**Chemung County Stormwater
Construction Inspection
Erosion and Sediment Control**

Project Name Glad Tidings Building Exp	Date 10-16-18
Location 116 Breesport Rd Horseheads, NY	Permit # NYR11C743
Weather Conditions Sunny, cool	Entry Time: 10:15 am
On-Site Representative Present: Bruce Patoka, Bella Facia	Exit Time: 10:45 am

PROJECT: Glad Tidings Church
Town of Horseheads
Municipal Construction Inspection
October 16, 2018

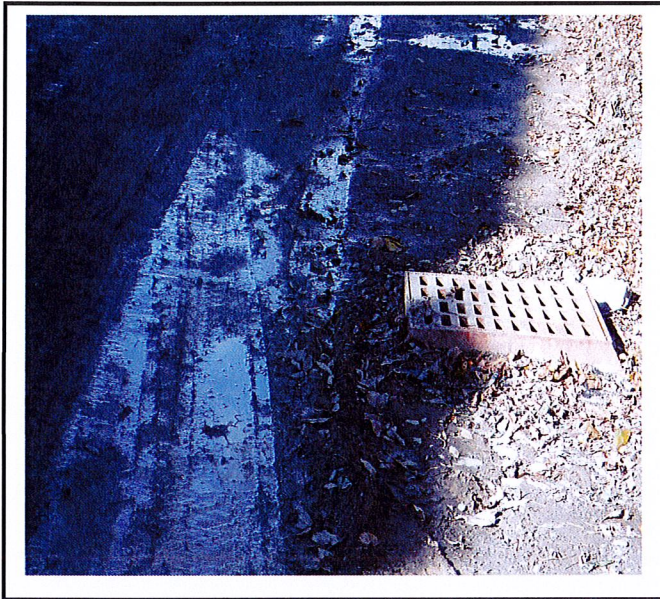
-Outlet protection not isntalled on forebay storm sewer. Mud has been placed in this area and will cause issues for stormwater basin.

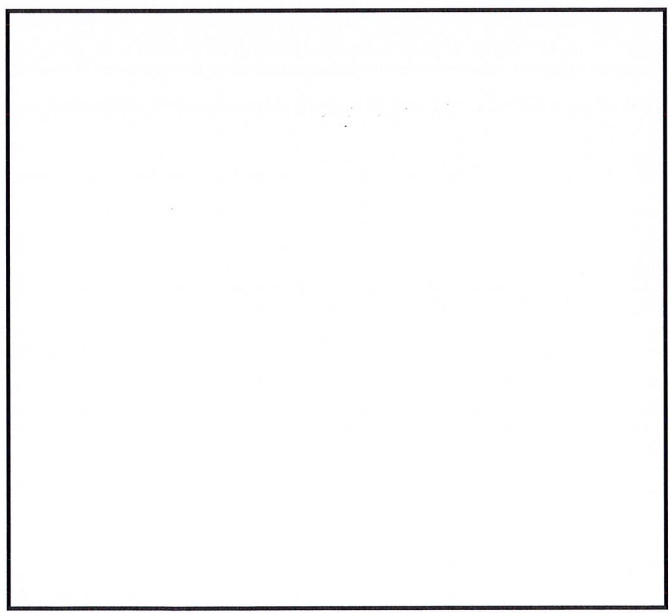
Outlet protection is not installed. Mud has been placed around the storm pipe.
